CUSTOMER NOTIFICATION

SUD-DT-03-0314-1-E (SUD-DT-02-0087-1-E revision)
July 31, 2003
Koji Nishibayashi, Senior System Integrator Microcomputer Group 2nd Solutions Division Solutions Operations Unit NEC Electronics Corporation

IE-V850E-MC (Control Code: A, B, C, D)
IE-V850E-MC-A (Control Code: B, C, D, E, F, G)

Operating Precautions

a-38. Restriction on DMAAK signal during DMA line transfer

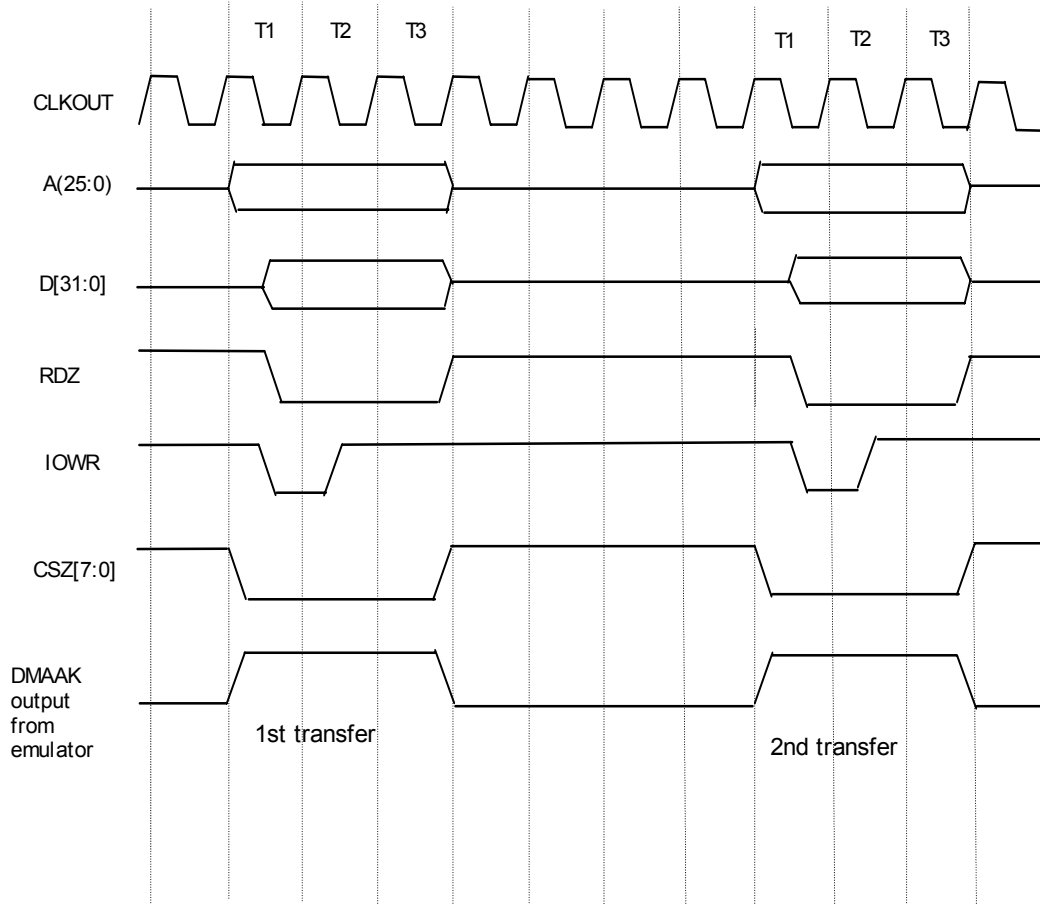
- When developing V850E/MA1, MA2:
This restriction does not apply because these products do not support line transfer.
- When developing V850E/IA1, IA2:
This restriction does not apply because these products do not support line transfer.
- When developing a system LSI:
This restriction does not apply and the DMAAK signal is output correctly as a DMACTV signal.

a-45. Restriction on page ROM access

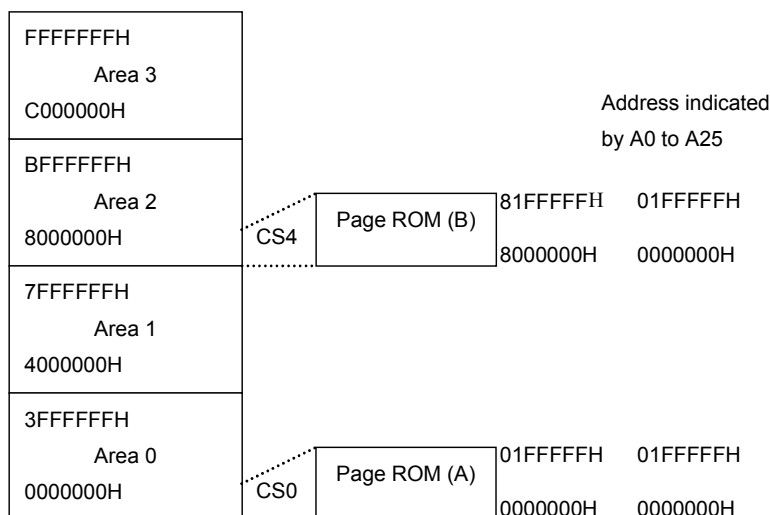
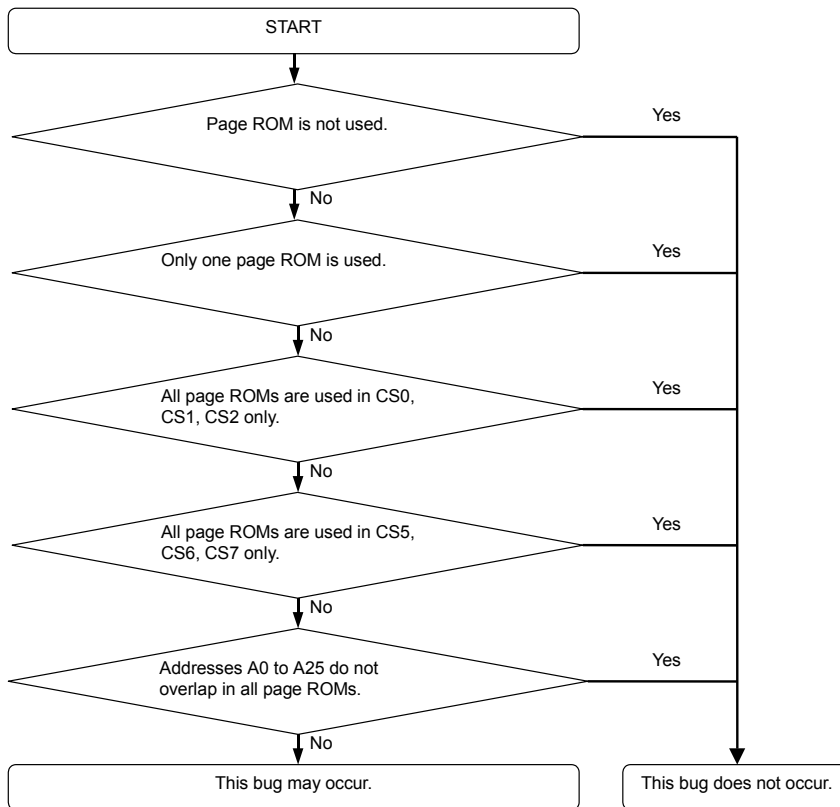
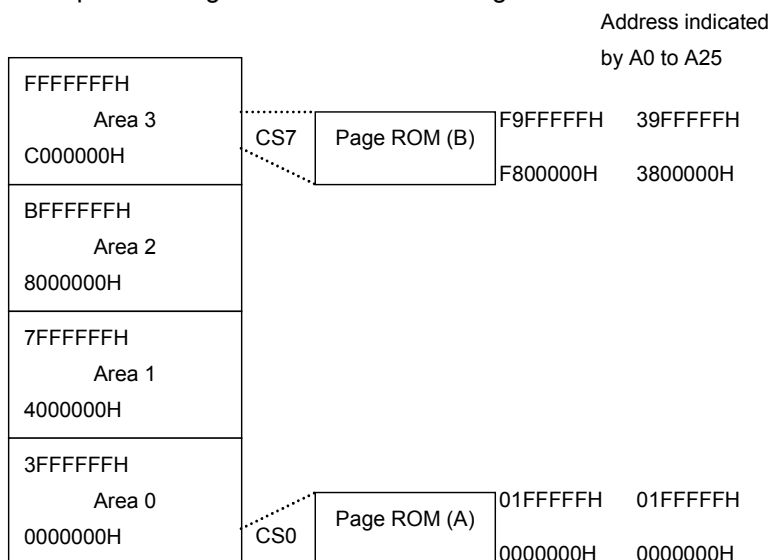
When a CPU data space is used in a system in which multiple page ROMs are connected to multiple CS areas, when a page ROM access and page ROM access to another CS area occur in succession, if the address value of the former address and that of the latter are within the same page length of the page ROM, it is judged that the same page ROM was accessed, even though the page ROMs with different CS areas were accessed. As a result, an on-page cycle will be issued for the latter access, but because the data access time for the latter access is insufficient, data cannot be read correctly.

Example of configuration in which this bug can occur

The following flowchart can be used to check whether this bug occurs or not. Confirm if this bug applies your company's product using this flowchart.

When multiple page ROMs are used, allocate addresses 25 to 0 so that they do not overlap in each page ROM.

For example, when allocating two 2 MB page ROMs to different CS areas, allocate one page ROM within addresses 0000000H to 01FFFFFFH, and the other within addresses F800000H to F9FFFFFFH.

Example of configuration in which this bug does not occur

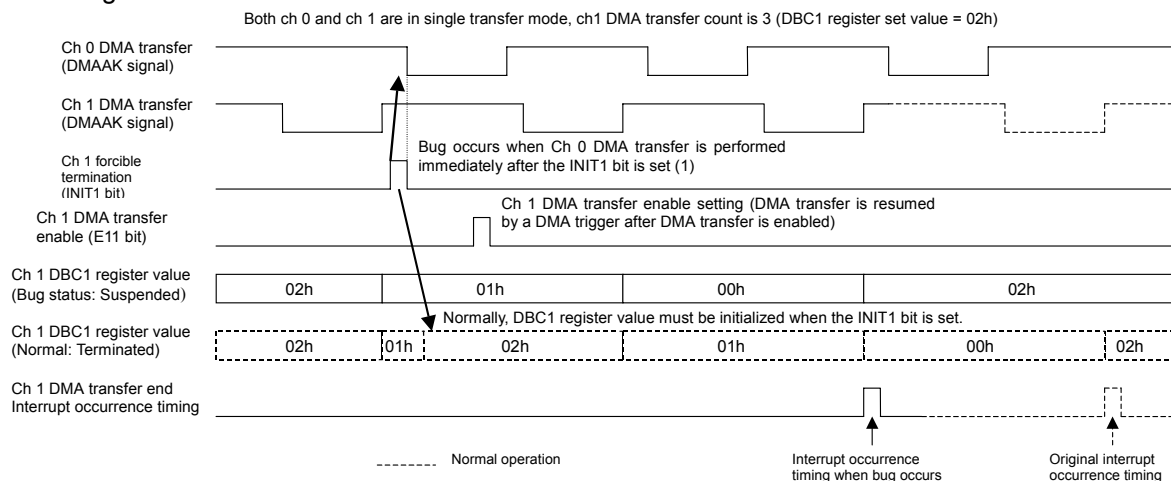
When terminating a DMA transfer by setting the INITn bit of the DCHCn register, the transfer may not be terminated, but just suspended, even though the INITn bit is set (1). As a result, when the DMA transfer of a channel that should have been terminated is resumed, the DMA transfer will terminate after an unexpected number of transfers are completed and a DMA transfer completion interrupt may occur (n = 0 to 3). This bug occurs if a DMA transfer is executed immediately after a forcible termination is set (by setting the INITn bit) (see the figure below).

This bug does not depend on the number of transfer channels, transfer type (2-cycle or flyby), transfer target (between memory and memory, memory and I/O; including internal resources), transfer mode (single, single-step, or block), or trigger (external request, interrupt from internal peripheral I/O, or software), and can occur with any combination of the above elements that can be set under the specifications. In addition, another channel may affect the occurrence of this bug.

The following registers are buffer registers with a 2-stage FIFO configuration of master and slave. If these registers are overwritten during a DMA transfer or in the DMA-suspended status, the value is written to the master register, and reflected in the slave register when the DMA transfer of the overwritten channel is terminated.

The "initialization" in the above figure means that the contents of the master register are reflected in the slave register.

Please regard this as a permanent restriction.

a-47. Bug that DMA transfer is forcibly suspended by NMI

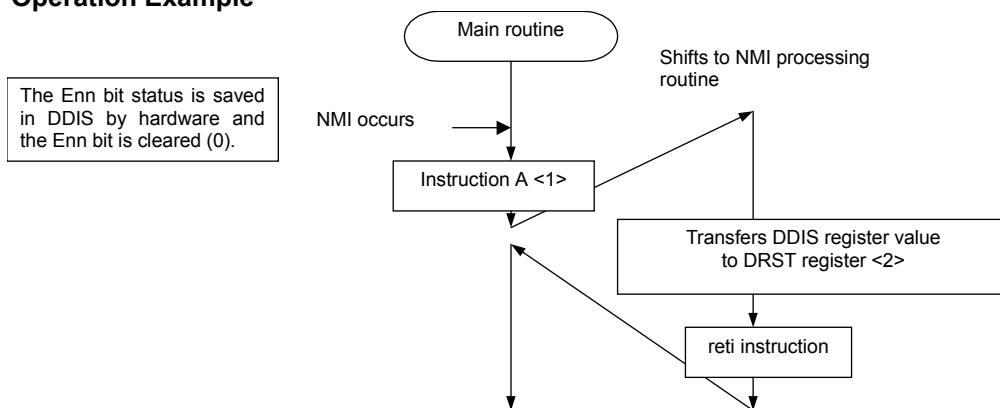
DMA transfer is forcibly suspended by an NMI input during a DMA transfer. At this time, the DMA controller saves the status of the Enn bit (bit 0 of the DCHCn register) of all the DMA channels to the DDIS register, clears (0) the Enn bit, and disables the DMA transfer. In addition, when an NMI interrupt is acknowledged in the CPU pipeline operation, an instruction that has already been fetched is executed (1 instruction max.).
